Midpeninsula Regional
Open Space District

R-19-144
Meeting 19-28
November 13, 2019

Change order approval and approval of an Addendum to the Project Initial Study/Mitigated Negative Declaration for the Ravenswood Bay Trail Connection Project located at Ravenswood Open Space Preserve for additional trail paving work.

Addendum to the Initial Study / Mitigated Negative Declaration

Exhibit 3 Approved Project Area

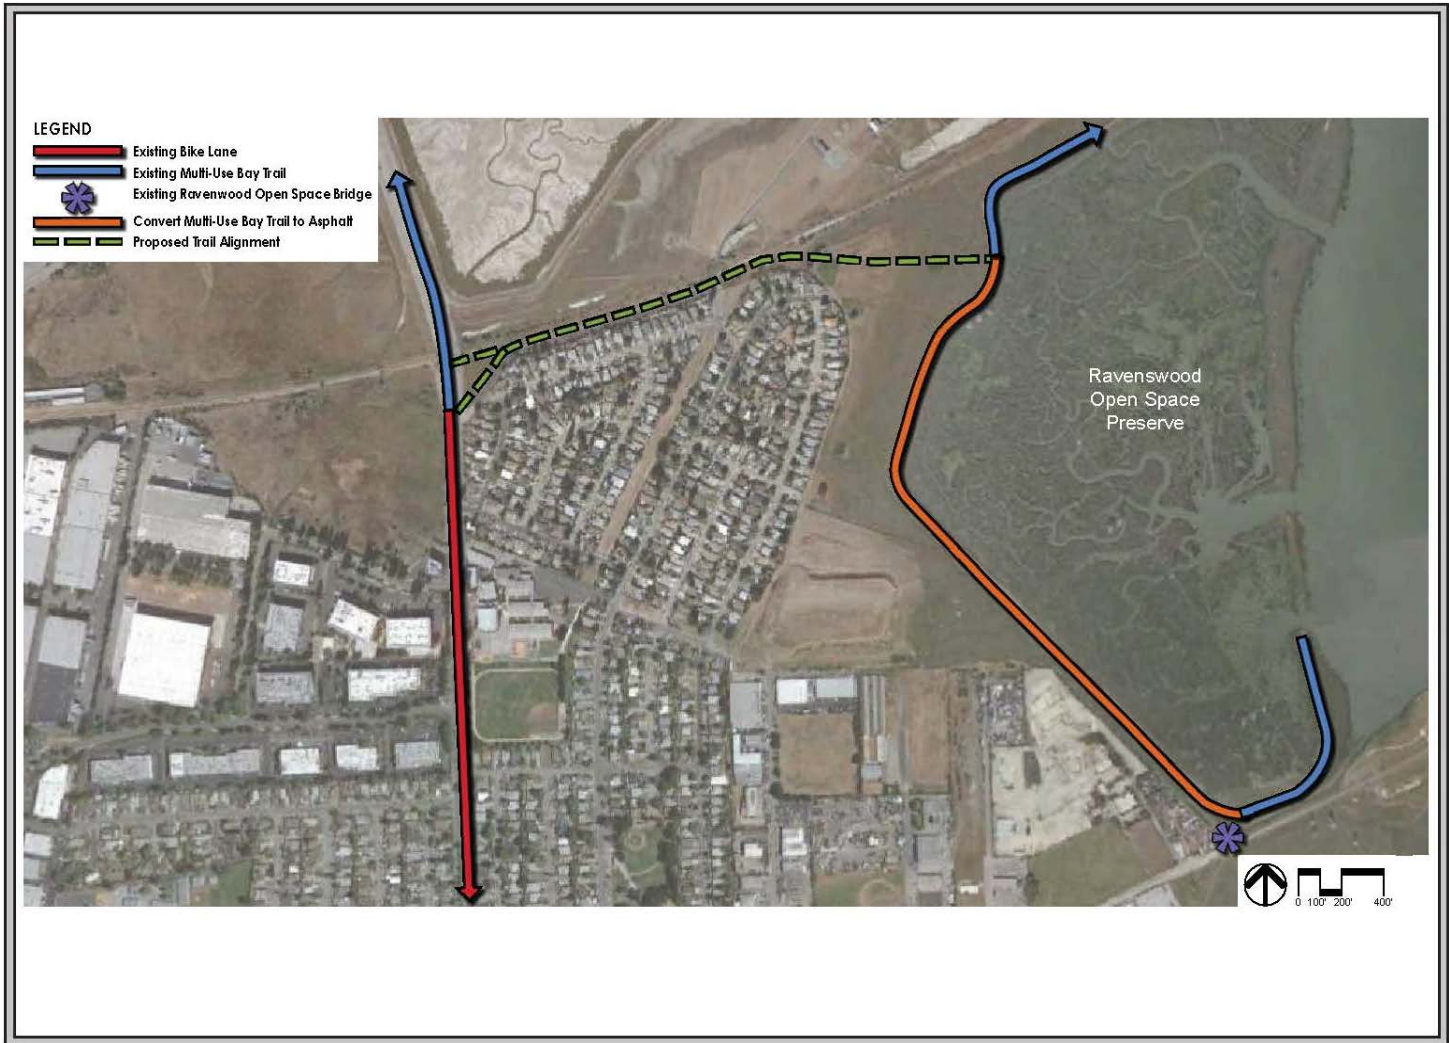
The approved project includes paving of approximately 3,600 linear ft (0.7 mile) of the existing Bay Trail that is located along the levee that surrounds the marsh within the Ravenswood OSP. This paving extends south from the new trail alignment's terminus to the southern terminus of the Bay Trail, located on the western perimeter of the Ravenswood OSP marsh. The newly paved trail would be approximately 8 ft wide with 2-ft shoulders on each side and would follow the existing Bay Trail alignment along the top of the levee bank. Resurfacing activities would be restricted to the top of the levee bank avoiding the ruderal levee slope and northern coastal salt marsh habitats in the adjacent areas.

The additional trail segments that the District is proposing to repave include 2,641 linear feet to the north of the approved project area and 653 linear feet to the south of the approved project area. These segments will be improved to the same details and specifications of the approved project. The existing paved pedestrian access route is directly adjacent to Bay Road and connects the existing Ravenswood OSP parking area to the existing pedestrian bridge leading to the levee top trail. The District is proposing to repave an 800 linear foot

section (8-foot width). All necessary permit would be secured prior to initiating the proposed work and applicable permit conditions, jurisdictional requirements and mitigation measures would be followed.

Project Site Map

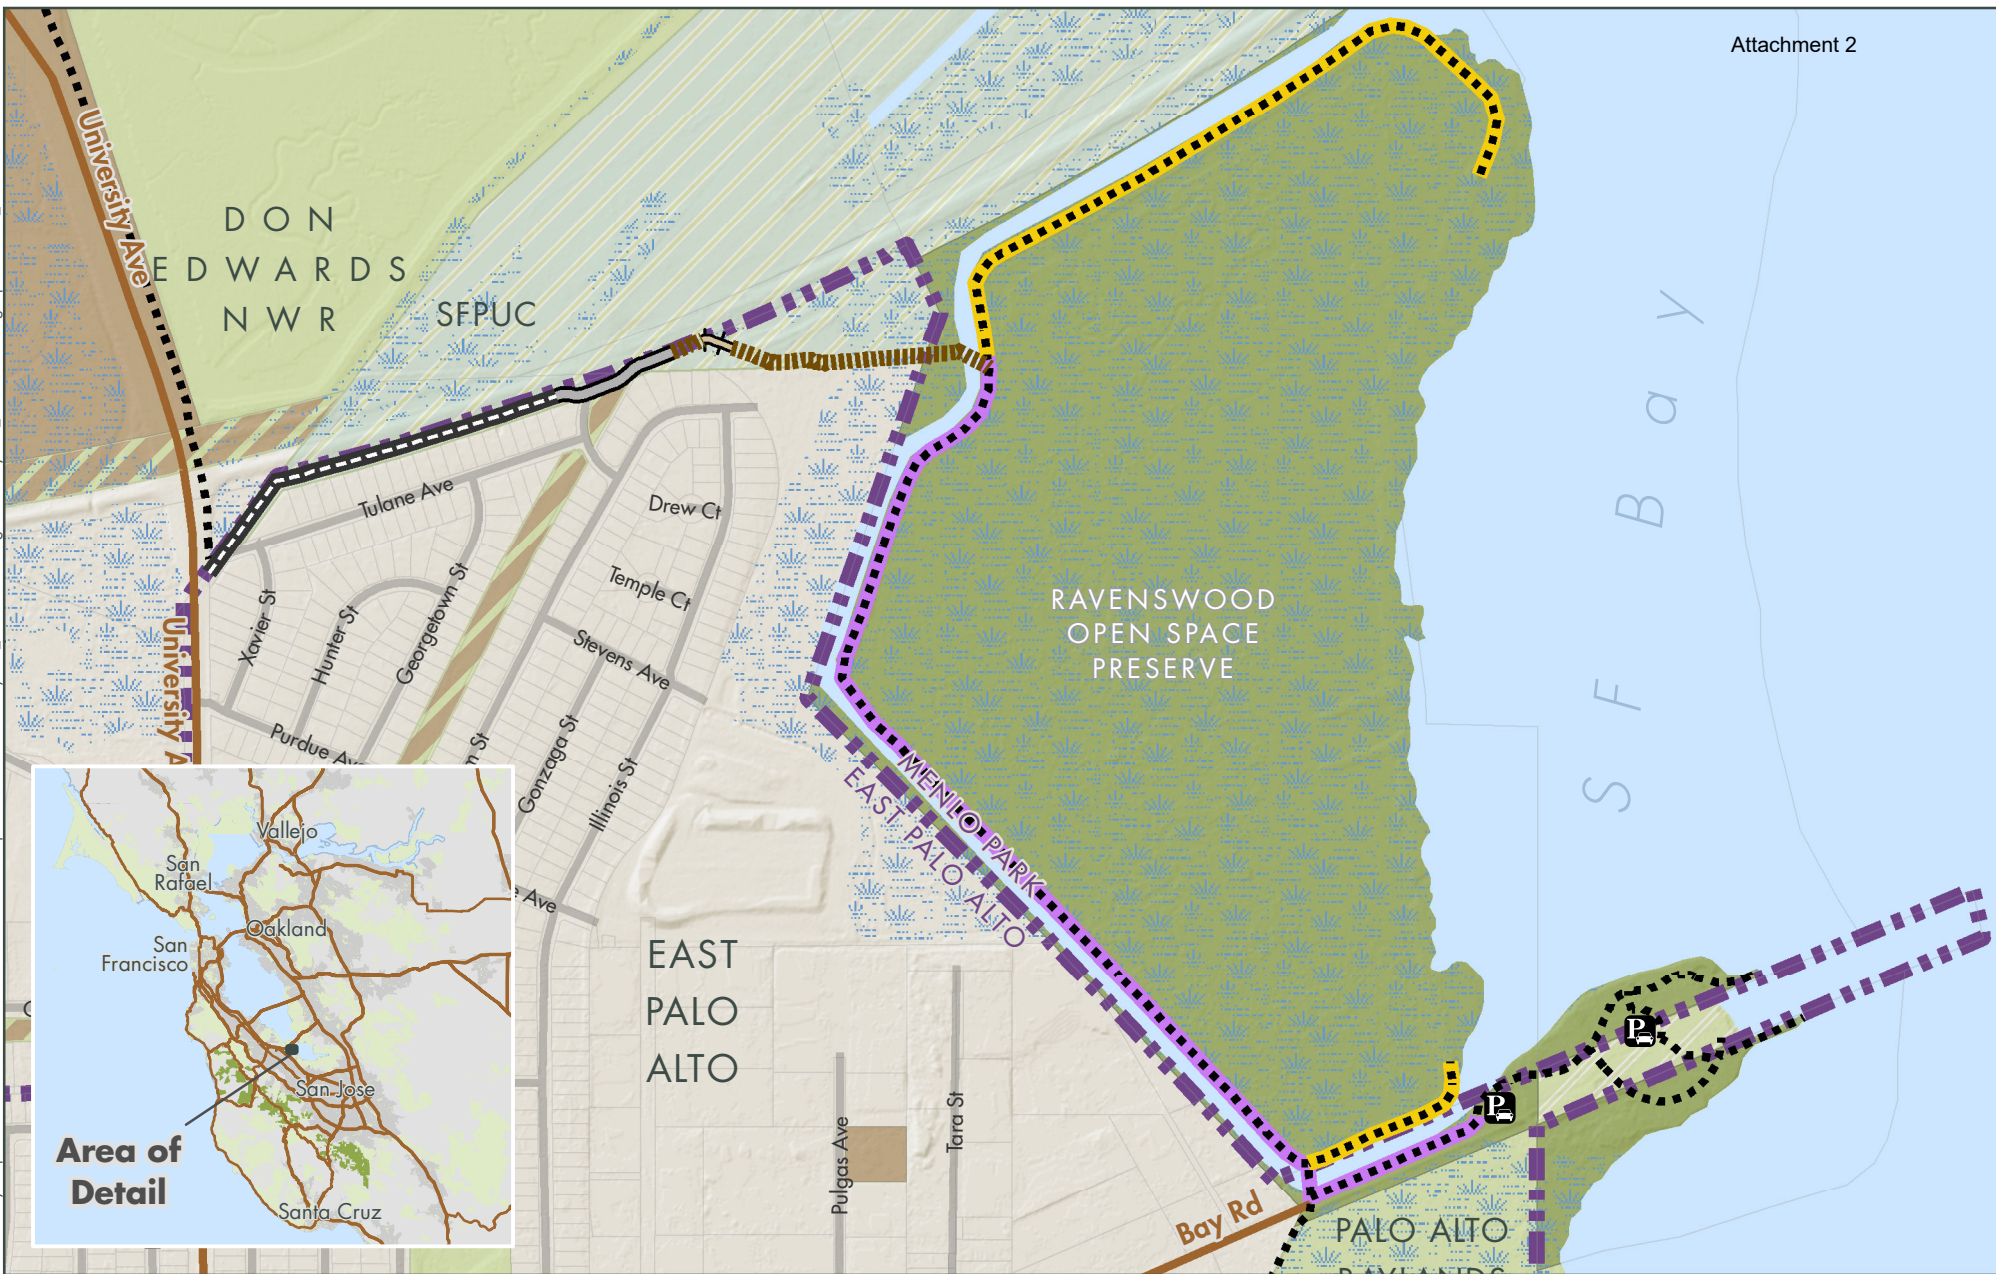
The additional scope of work for the Project is to resurface an 8 foot wide trail, 2,641 linear feet to the north of the contracted work and 653 linear feet to the south of the contracted work. The scope is to pulverize the existing asphalt, re-construct the base, and install new asphalt capable of supporting pedestrians, bicycles, and maintenance vehicles. With the additional work, the entire levee trail that surrounds Cooley Marsh will be improved as an easy access trail that meets Architectural Barriers Act (ABA) standards.
